UNITED STATES
NUCLEAR REGULATORY COMMISSION
WASHINGTON, D. C. 20555

Docket Nos: 50-424
and 50-425

APPLICANT: Georgia Power Company
FACILITY: Vogtle Electric Generating Plant, Units 1 & 2
SUBJECT: SUMMARY OF OCTOBER 3, 1984, MEETING REGARDING
TRANSMISSION LINE CROSSING AT EBENEZER CREEK SWAMP -
VOGTLE ELECTRIC GENERATING PLANT, UNITS 1 & 2

Enclosure 2 - Ebenezer Creek Swamp: alternate route selection

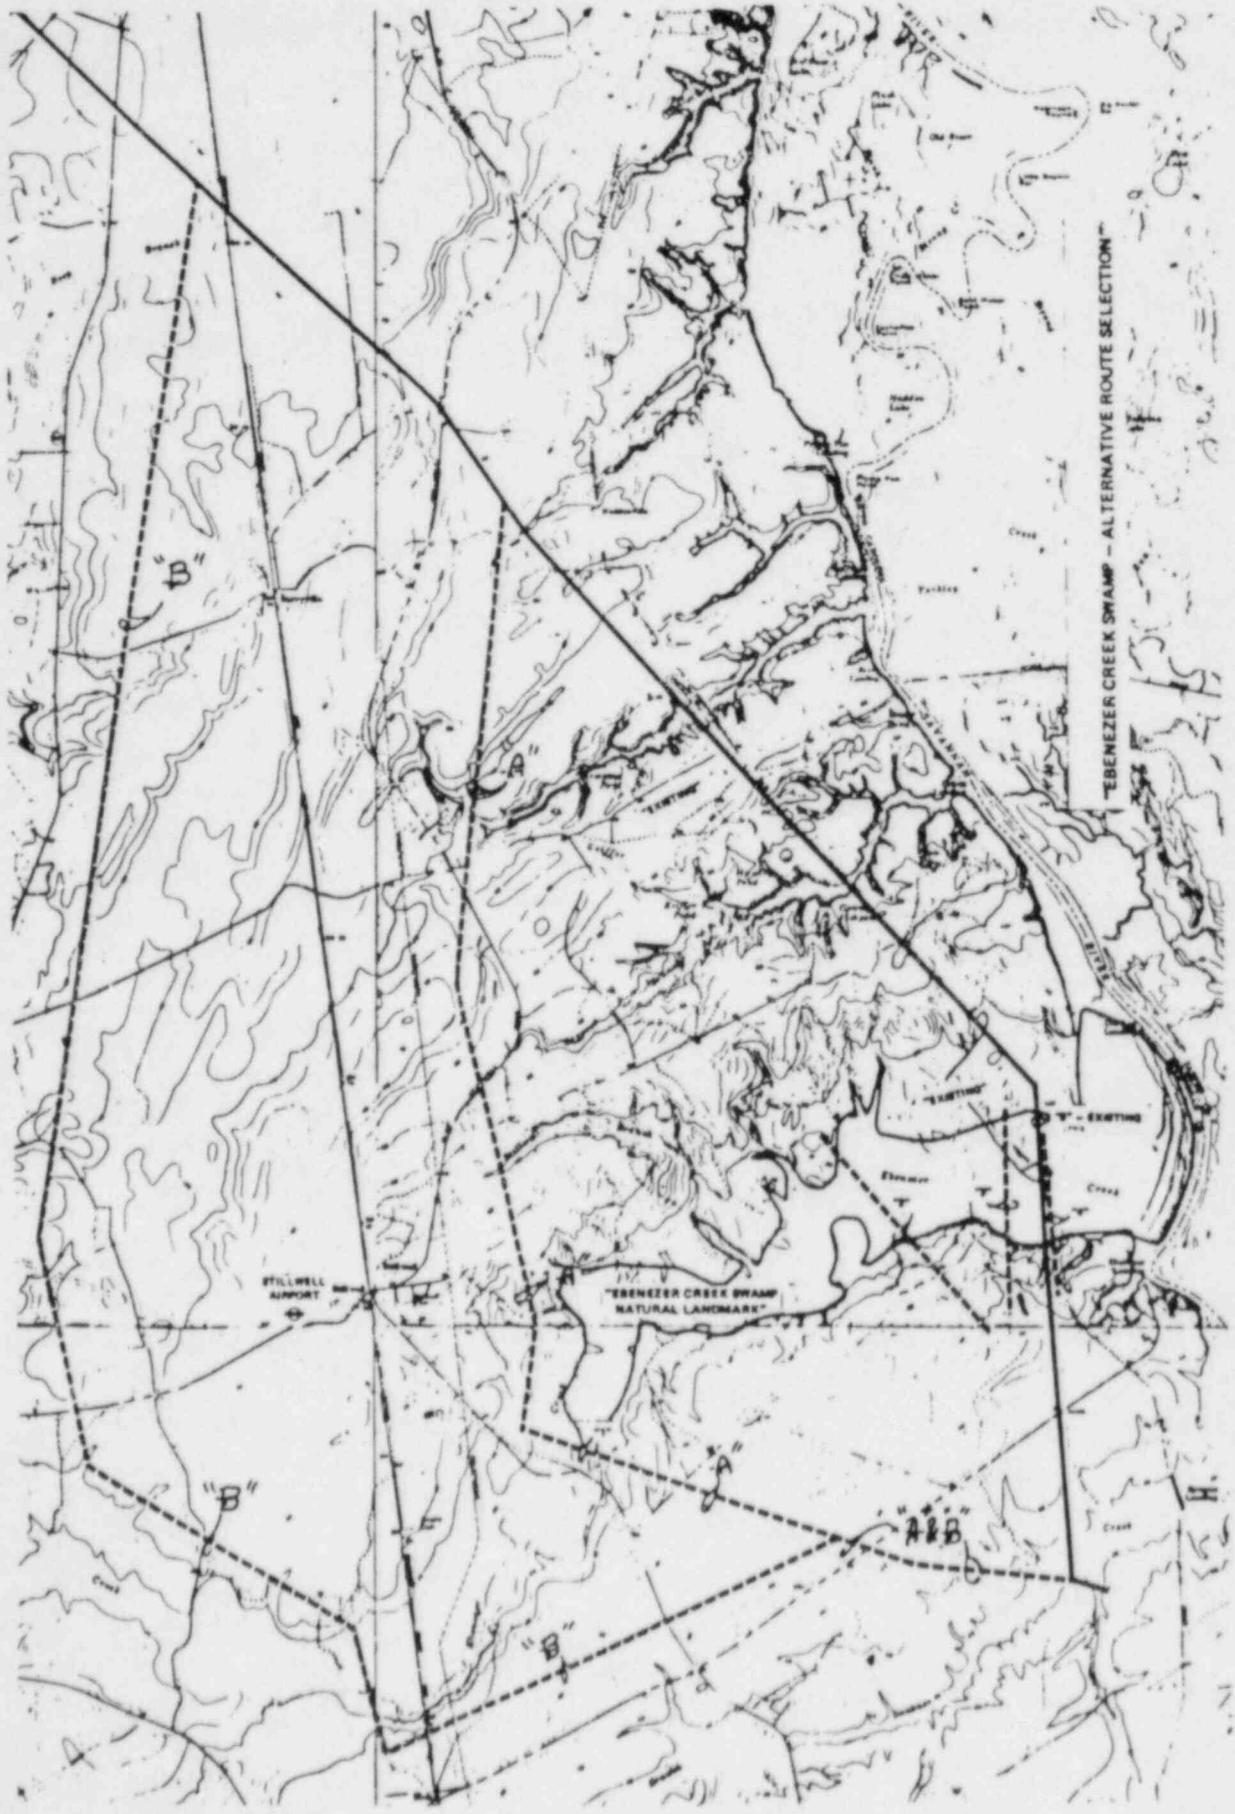
The applicant responded on August 24, 1984, with a report on preliminary studies of alternatives and mitigative actions. This report considered alternatives for crossing Ebenezer Creek Swamp area, and included the approximate additional cost for two of these, designated alternatives A and B (shown on Enclosure 2). Alternative B would entirely avoid the landmark; alternative A would cross the landmark at its western boundary.

The applicant also provided an updated evaluation of alternative A which would cross Ebenezer Creek parallel to an existing transmission line owned by another utility on the western boundary of the National Landmark. From the crossing to the proposed Effingham substation, the existing line is in close proximity to several houses. To route a 500-kV line parallel to the existing line would require purchasing those homes or going around them. Alternate A was thus found to result in much higher costs and more impact on the community, than was indicated by the preliminary study of August 24, 1984.
